FORD 4R70W /4R70E/4R75E 2003-UP

NO SPEEDOMETER READING OR SPEEDOMETER READING SLOW

Figure 1

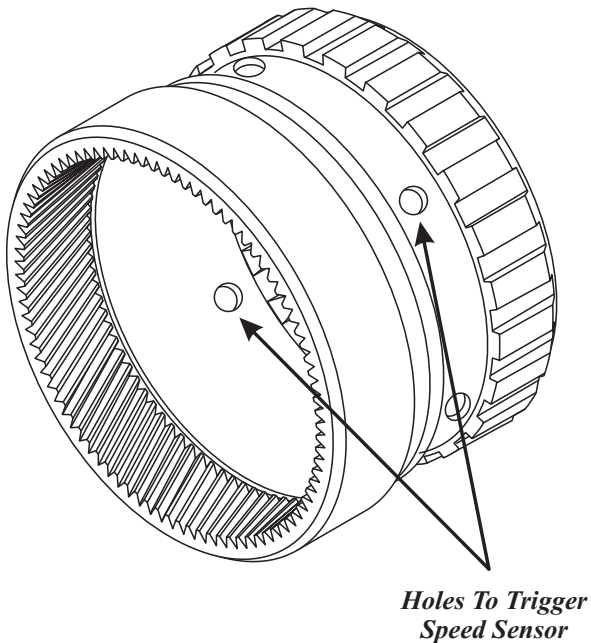
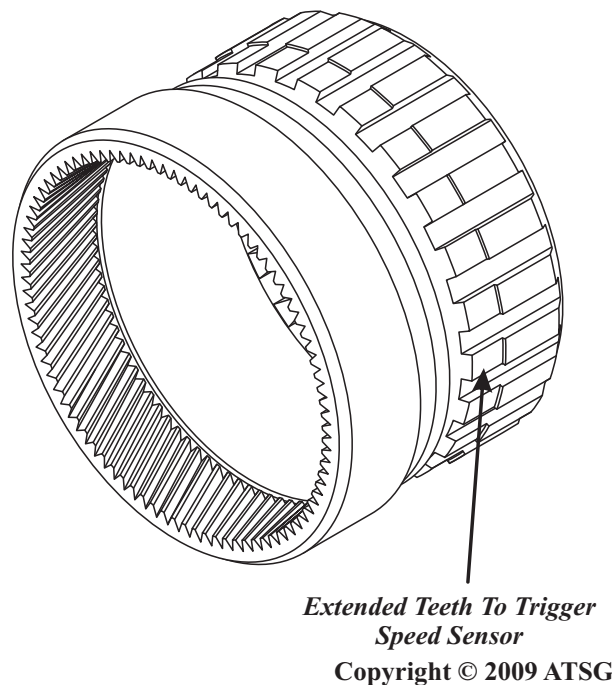
CAUSE: Beginning at the start of production for the 2004 model year, this family of transmissions is manufactured with extended parking lugs on the ring gear to trigger the output speed sensor, instead of the previous design with holes in the ring gear, which also required a strategy change in the PCM. If either a transmission earlier than 2004, or the use of 2003 or earlier ring gear is installed in a 2004-up vehicle, the PCM will not be able to correctly calculate vehicle speed, and will result in either no speedometer reading, or a slow speedometer reading. DTC's P0720-P0722 may be set. The 2004-up Rear Ring that has the extended park lugs utilizes the Output Shaft Speed Sensor with the white body, and a black connector (See Figure 5). The 2003-earlier units had the Rear ring gear with the holes, and utilizes the all black Output Shaft Speed Sensor, which is .083 inches longer than the 2004-up Output Shaft Speed Sensor (See Figure 4).

CORRECTION: Make sure that either during overhaul, or transmission exchange, the correct Rear Ring Gear, and Output Shaft Speed Sensor is used. (See Figures 4 and 5).
